UNITED STATES PATENT AND TRADEMARK OFFICE

Office Action Summary

10/627,225

YBARRA, LUIS M.

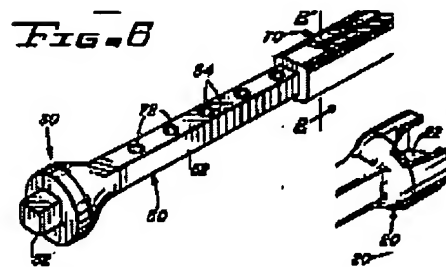
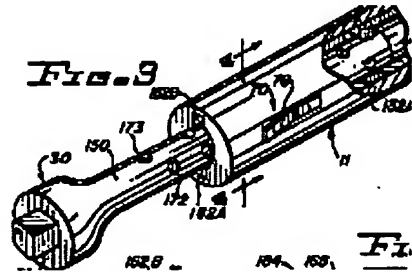
7. Claims 1-20 are rejected under 35 U.S.C. 102(b) as anticipated by or, in the alternative, under 35 U.S.C. 103(a) as obvious over Newby et al. (4,376,397) in view of McBride (4,409,86) or Mathews (4,960,015).

Newby et al. discloses all of the limitations of claims 1, 11 and 16, i.e., an adjustable extension for driving tools comprising an outer tubular member (60) (160), the outer tubular member having a proximal end and a distal end, the adjustable extension having a longitudinally extending connector (50) (150), the longitudinally extending connector having a proximal end and a distal end, the outer tubular member having a receiver (22) at the proximal end thereof for receiving a driving tool, the tubular member having a longitudinally extending central cavity, the central cavity having a non-circular cross-section, the adjustable extension further having the longitudinally extending connector adjustably received within the longitudinally extending central cavity of the tubular member for relative telescoping movement thereto, the longitudinally extending connector having its proximal end received within the central cavity of the tubular member, the proximal end of the longitudinally extending connector having a non-circular cross-sectional shape cooperating with the central cavity of the tubular member, the longitudinally extending connector having its distal end extending out of the longitudinally extending central cavity and beyond the distal end of the tubular member, the distal end of the longitudinally extending connector having a tool driving member (32), the longitudinally extending connector having an intermediate portion between its proximal and distal ends, the intermediate portion of the longitudinally extending connector being substantially circular in cross-section and being of

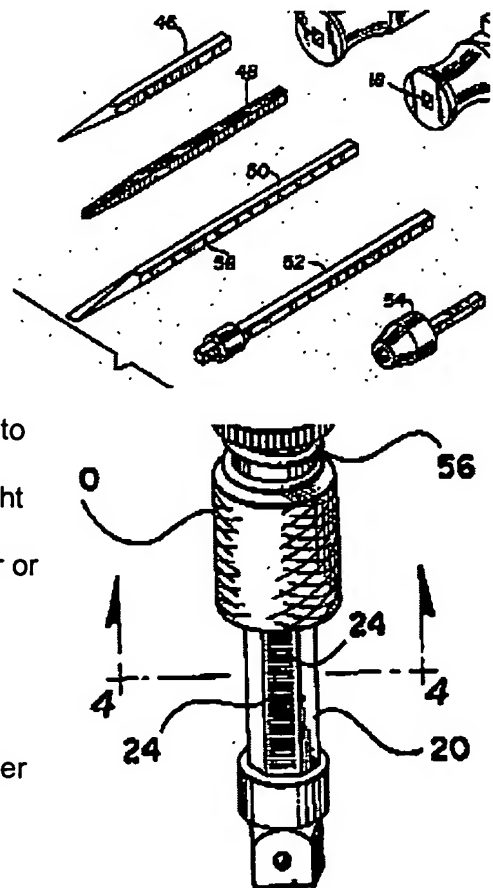
Note that the limitation of a "rack with teeth" is considered met by the (52 (72) as broadly defined, however, in the alternative, as evident by McBride, notches in form of a longitudinal slots closely placed together (Fig. 2) or teeth as defined by Mathews to engage with the pawl, are known in the art. It would have been obvious to one of ordinary skill in the art, at the time the invention was made, to modify the invention of Newby et al. with the "teeth" as taught by either McBride or Mathew to adapt the tool for more finer or smaller degree of adjustment.
